HUDDERSFIELD

DESIGN & ACCESS STATEMENT ADDENDUM

SEPTEMBER 2024

Fig. 2.2.5 Amended Proposals - Level 01

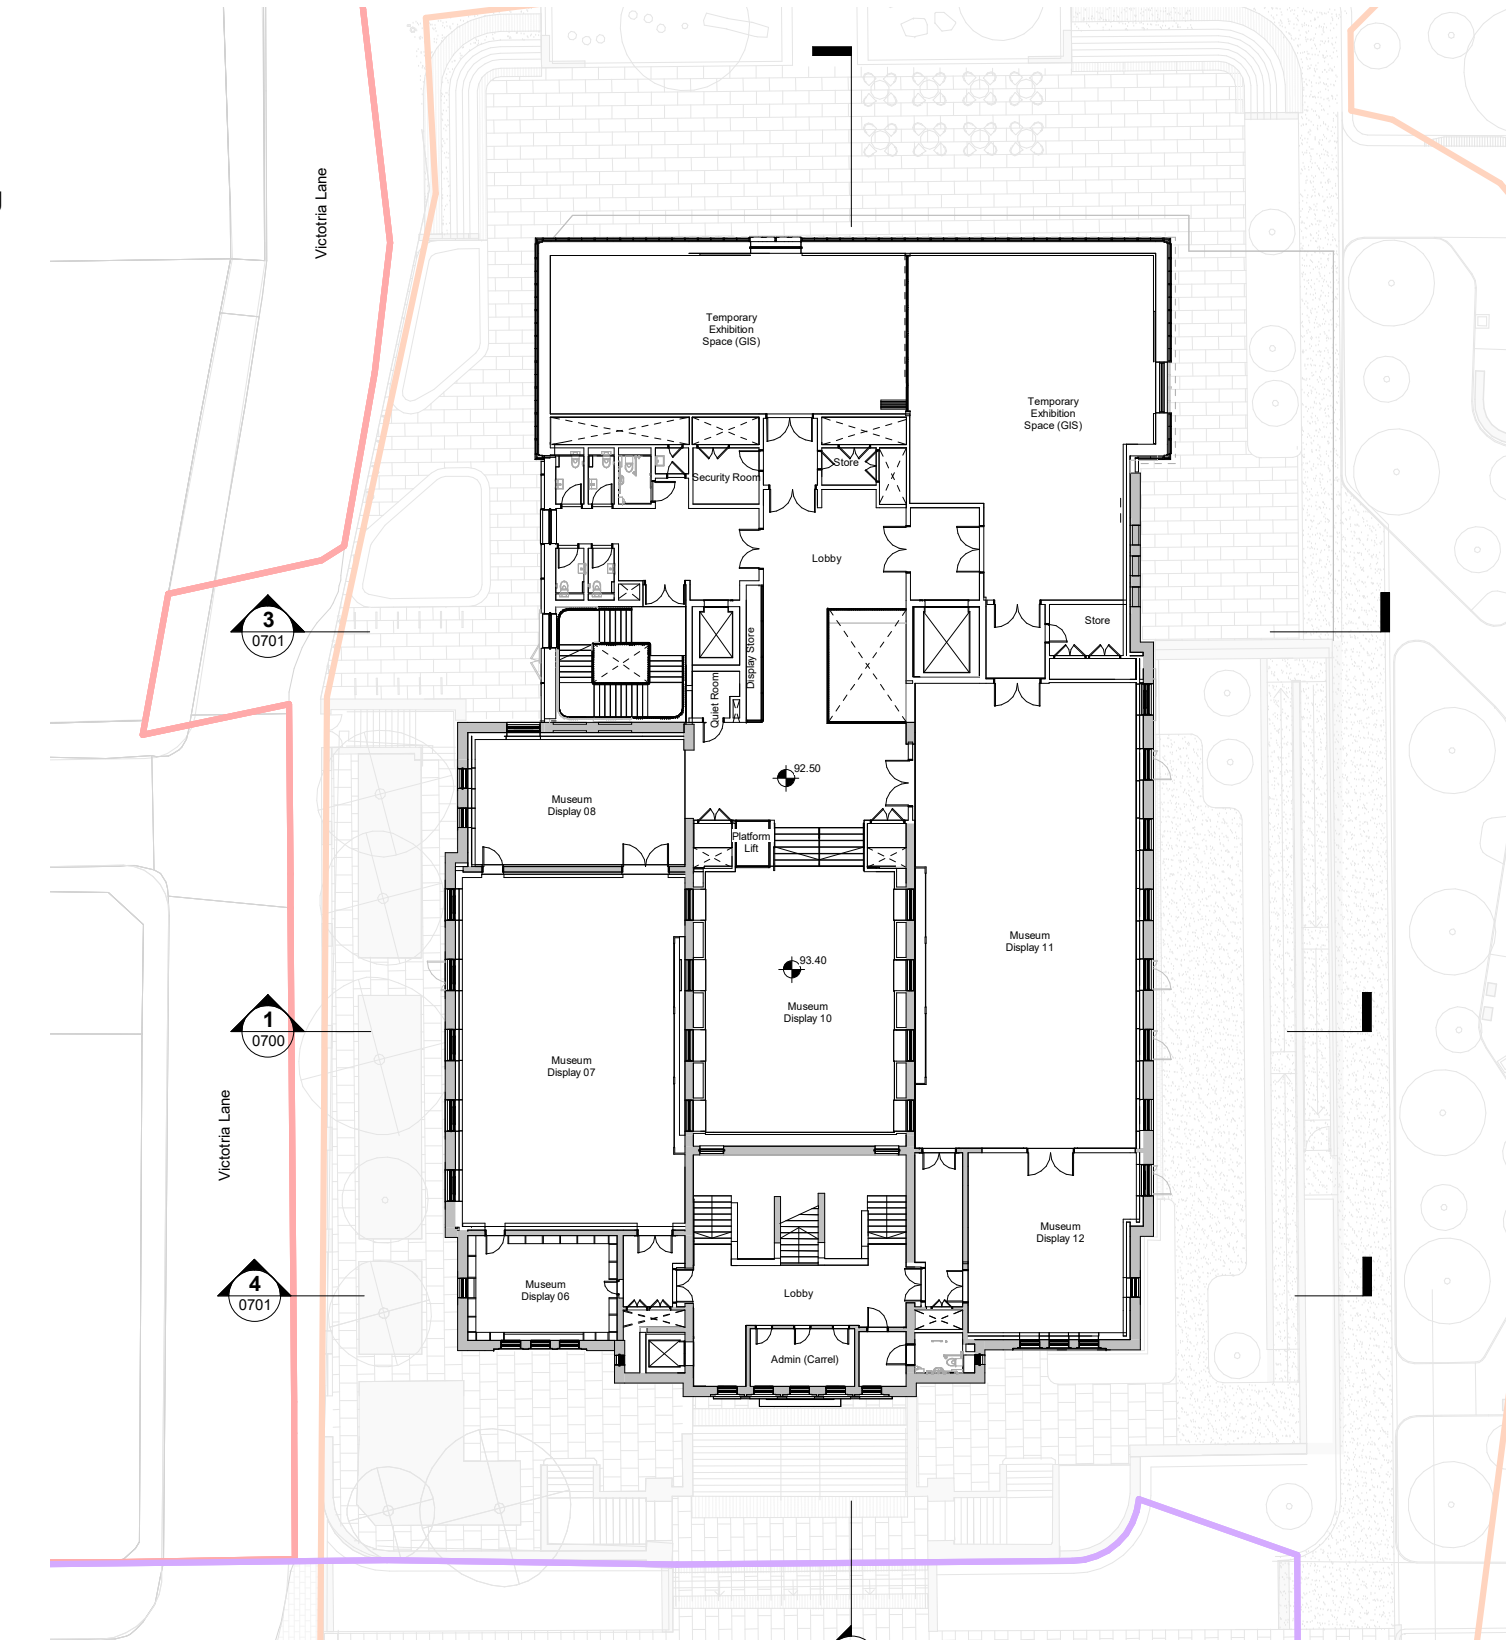
Following the changes to the location of the stairs to the north west, and lift core to the east, this has enabled a larger wrap around display space for temporary exhibitions. Similar to the floor below this also enables the eastern room within the existing building to be mostly untouched in terms of extents, providing space for museum display. The existing windows within the Temporary Exhibition Gallery are to be infilled with stone externally to enable greater flexibility for exhibition and displays. Windows locations within the new build facade have been updated to provide views of the later phased park alongside the surrounding context.

Display and circulation space replaces the previously proposed central stair. a new stair to the west will serve as both a front of house and means of escape stair. Windows have been added to the west creating a generous and a dramatic route throughout the new stair.

Fig. 2.4.3 Proposed North Elevation

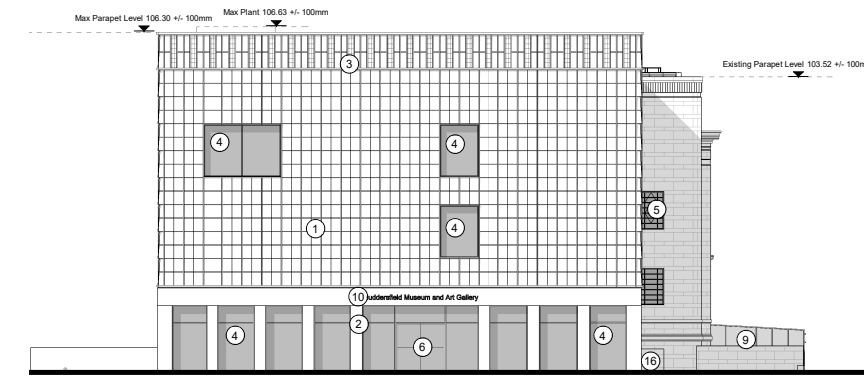
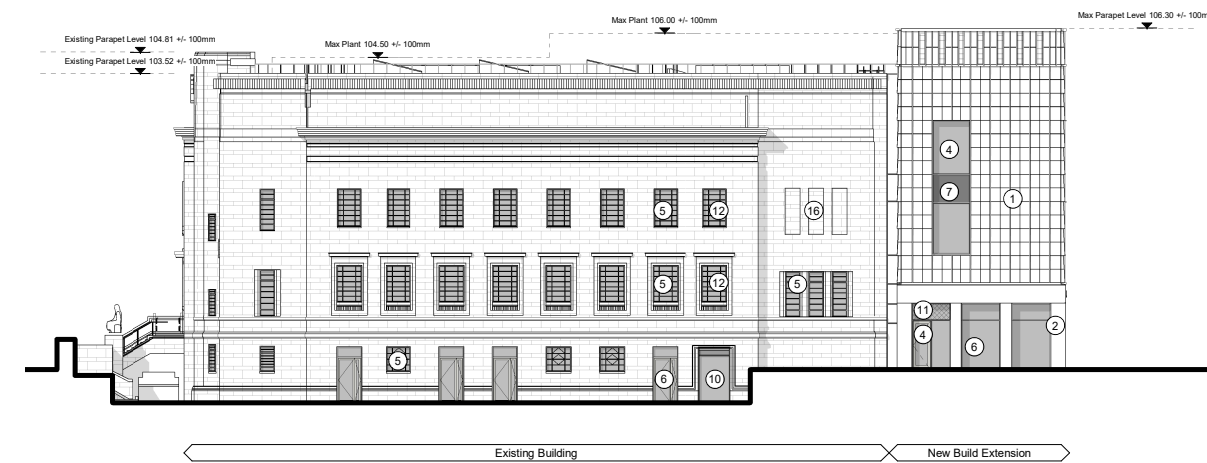
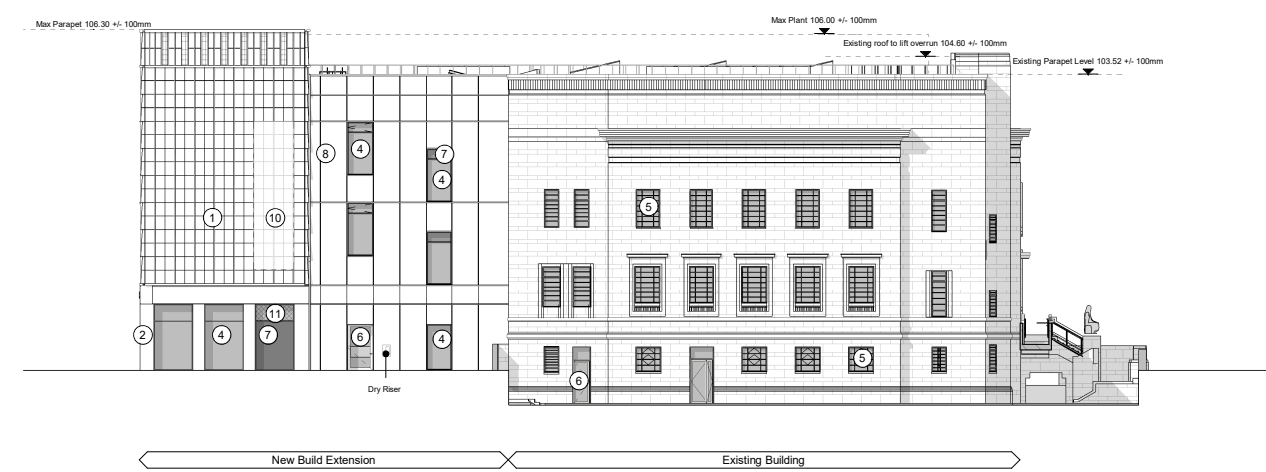
Following the relocation of the new entrance from the east elevation to the north elevation of the extension, the base piers have been adjusted to emphasis the point of entry and to accommodate an entrance of the right scale.

This change has allowed nearly full retention of the existing eastern fabric, with an amendment to the Level 01 existing windows which are proposed to be removed and infilled, allowing greater flexibility to the Temporary Gallery space internally.

Due to the removal of the north west core, and increase in gallery spaces on the upper floor, the window locations to the north and west elevation have been amended to suit. Alongside this, the new location of the western stair has seen amendments to the west metal facade window locations, now providing views out and natural light into the each stair level.

4.7.1 PHASE 1 INTERFACE / SOUTHERN ENTRANCE

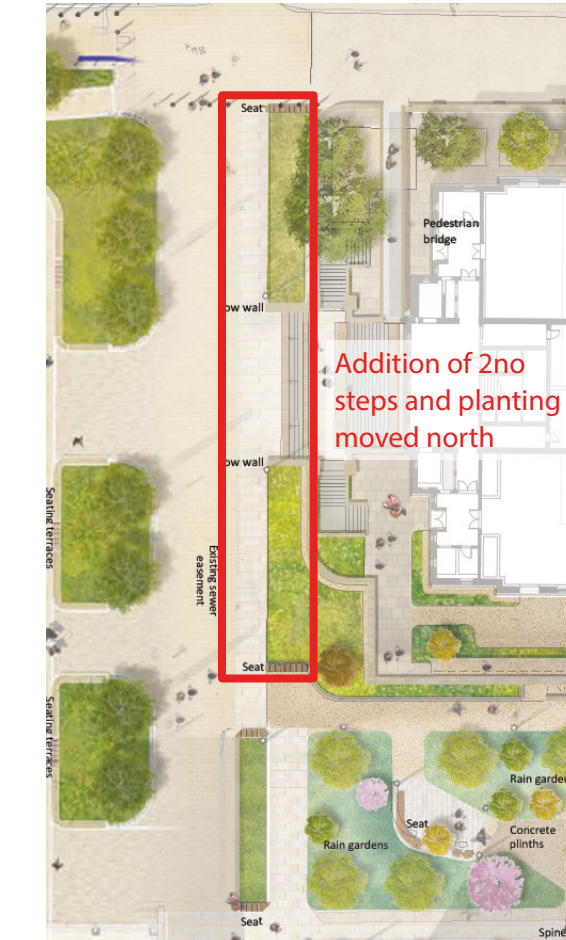
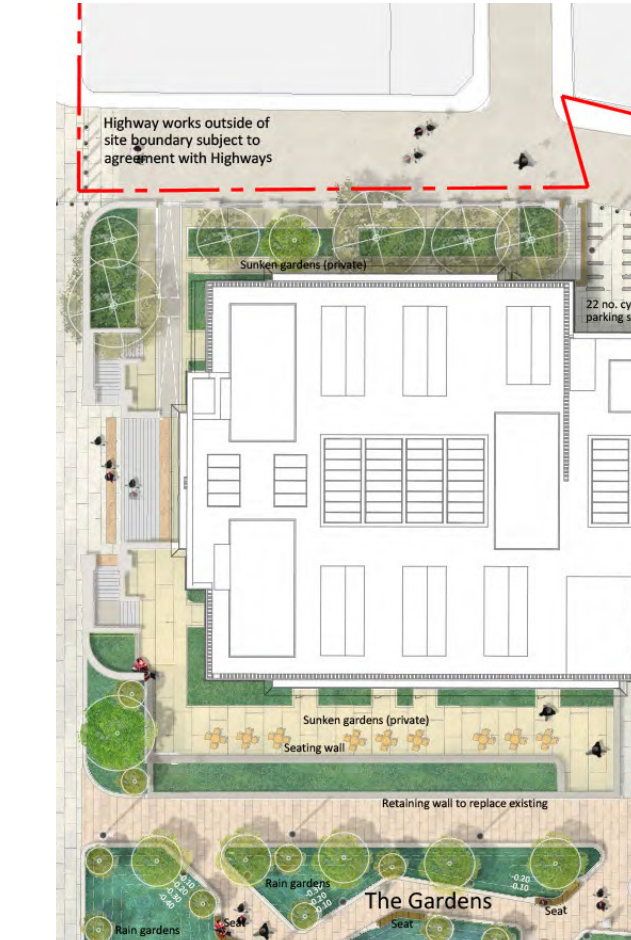
S73 application
2no. steps introduced to minimise impact on public realm levels adjacent to listed structures. Proposed planting bed moved northwards to sit closer to listed wall.

4.7.2 EASTERN TERRACE

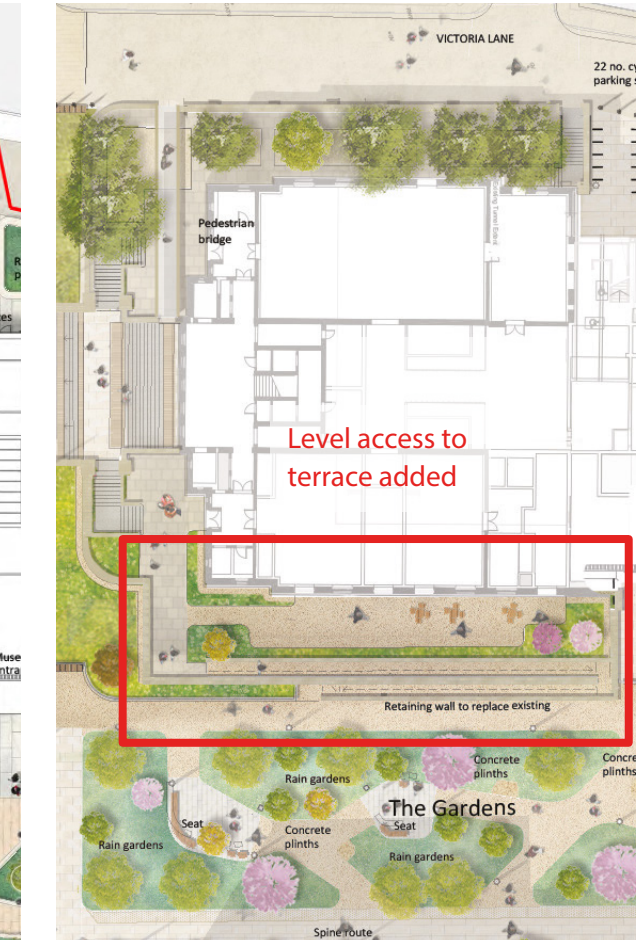
S73 application
Sloping footpath route and associated retaining walls and planting. Included as a means of access/egress to the lower ground floor.

4.7.3 NORTH ELEVATION / PHASE 4 INTERFACE

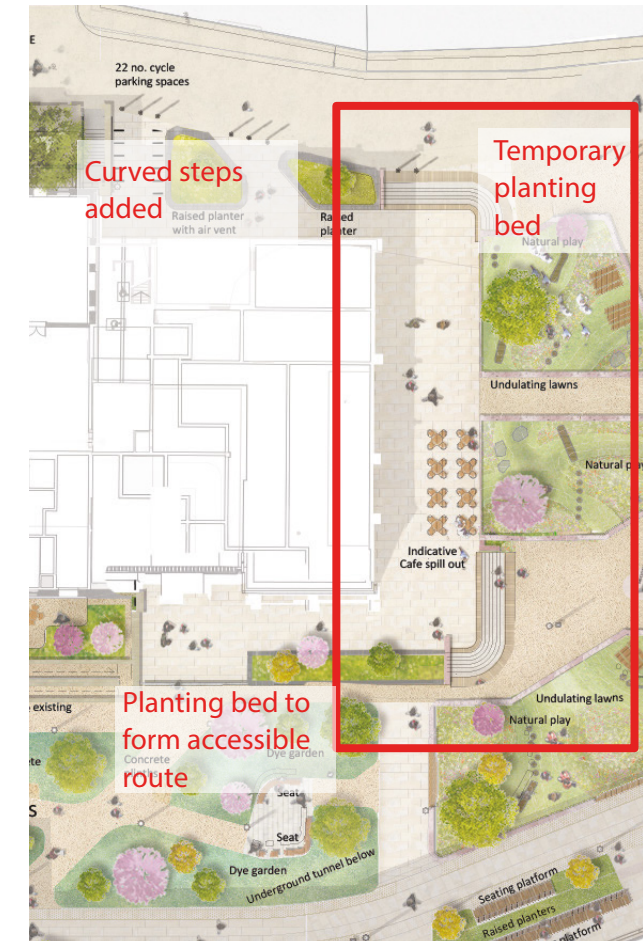
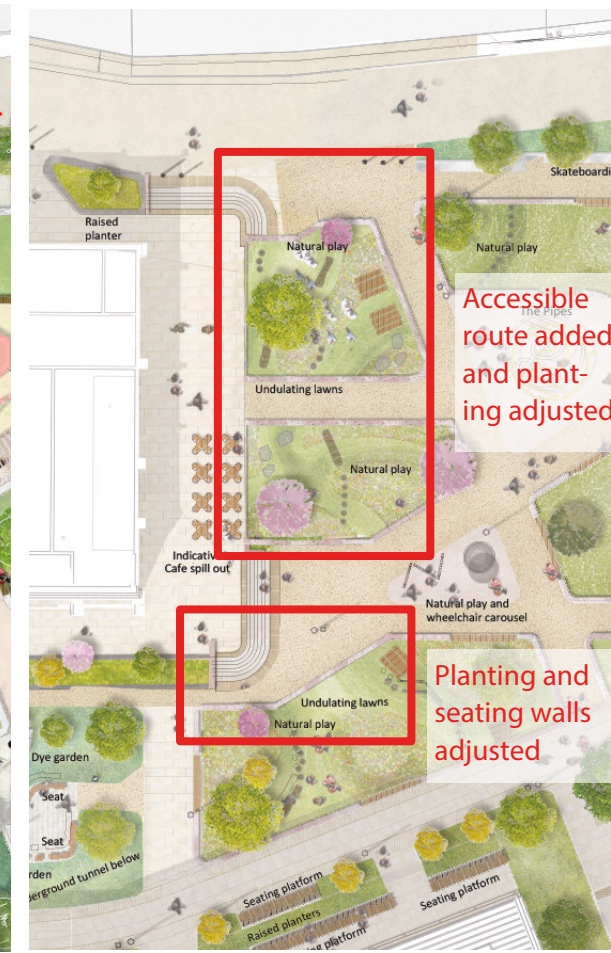
S73 application
Curved steps added to north east and north west corners to provide direct access to northern MAC entrance from main approach routes.

Planting bed added to north eastern corner to create an attractive level access route from the north to the north entrance of the MAC.

Temporary planting bed added between stepped approached to manage level change between existing and proposed public realm.
